STAFF RECOMMENDATION 406 Broadway August 16, 2017

Application: Alterations

Description of Project: Request is to replace the first and second story windows and to alter the height of the transoms on the storefront addition.

Figure 1: 406-408 Broadway (408 Broadway is on the left; 406 Broadway is on the right)

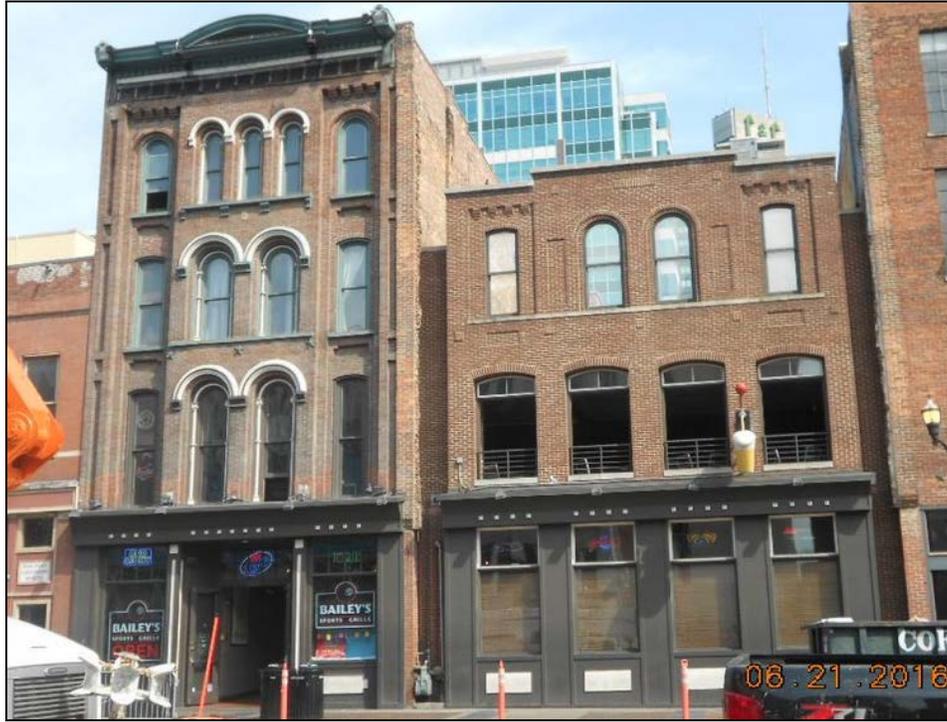
Background: The building located at 406 Broadway was constructed c. 2001 as a side addition to the historic Victorian commercial building located at 408 Broadway, which previously was home to Friedman Music and Loan Co. The building at 406 Broadway does not include an entryway but rather is served by the storefront entryway at 408 Broadway. The three-story building at 406 Broadway does not contribute to the character of Lower Broadway. (Figure 1)

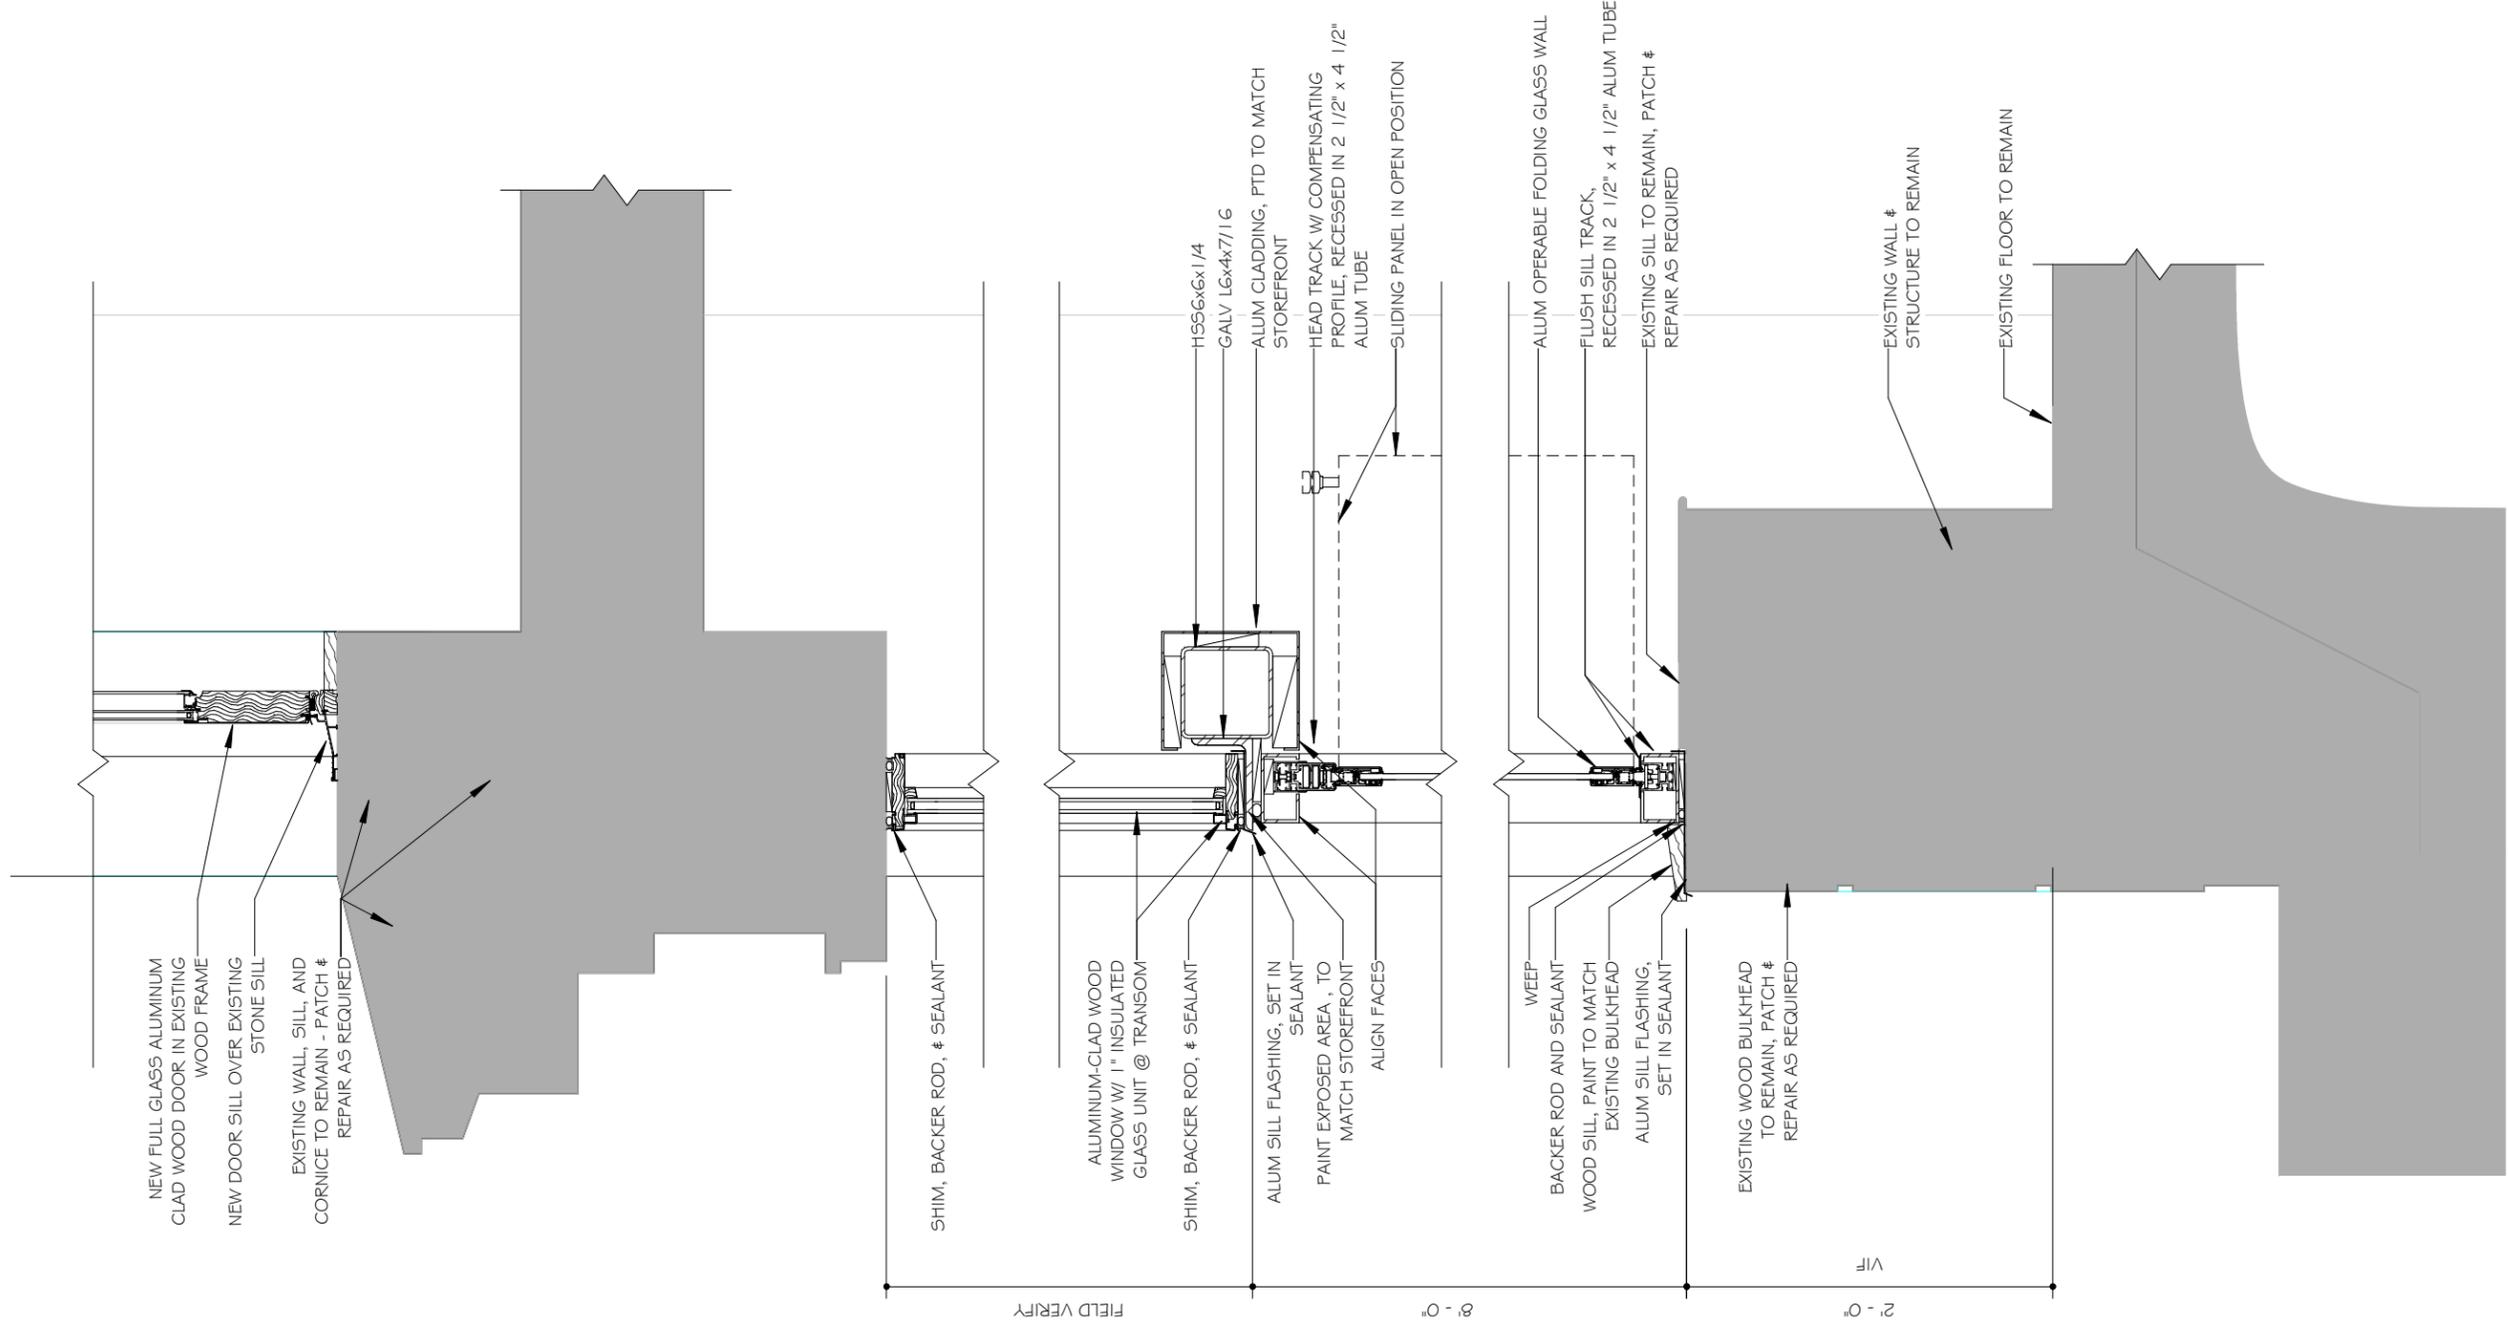
The applicant also proposes to replace the existing storefront windows with an operable aluminum framed glass window wall system. The proposal includes reducing the height of the existing transom by half. No changes to the bulkhead are proposed. Historically, transoms lined up with the top of the door opening. While the storefront at 408 Broadway has been altered, an appropriate transom height is reflected in the reconstruction (Figure 1). Other examples of historic storefronts that also illustrate appropriate transom height include 101 Broadway (Figure 2) and 401 Broadway (Figure 3).

Staff finds that replacing the existing storefront windows with a glass wall system could be appropriate as long as the plan maintains a transom and window height that is appropriate for the context. In this case, the window and transom heights should complement the historic structure at 408 Broadway, which includes transoms that reflect an appropriate historical height.

The proposed alterations to the storefront window and transom height are inappropriate as the proposed transom height is not compatible with historic transom heights. Section III.A.1 of the design guidelines states that “the relationship of width to height of windows and doors and the rhythm of solids to voids in new buildings shall be visually compatible with the surrounding buildings.” Additions as well as changes to non-contributing additions should be compatible with surrounding buildings. As stated previously, the building at 406 Broadway is a side addition to the historic building at 408 Broadway (Figure 2). Altering the transom height at 406 will not be visually compatible with the storefront proportions on the historic building. For this reason, staff finds that the proposal does not meet Section III.A.1 of the design guidelines. Staff finds that revising the proposal so that the height of the transom windows on the first-story are similar to the existing storefront transom windows on both 406 and 408 Broadway would meet the design guidelines and recommends this as a condition of approval.

1. The height of the transom windows on the first-story be the same height as the existing transom windows and those on the storefront of 408 Broadway; and
2. Staff approve the windows and doors prior to purchase and installation.
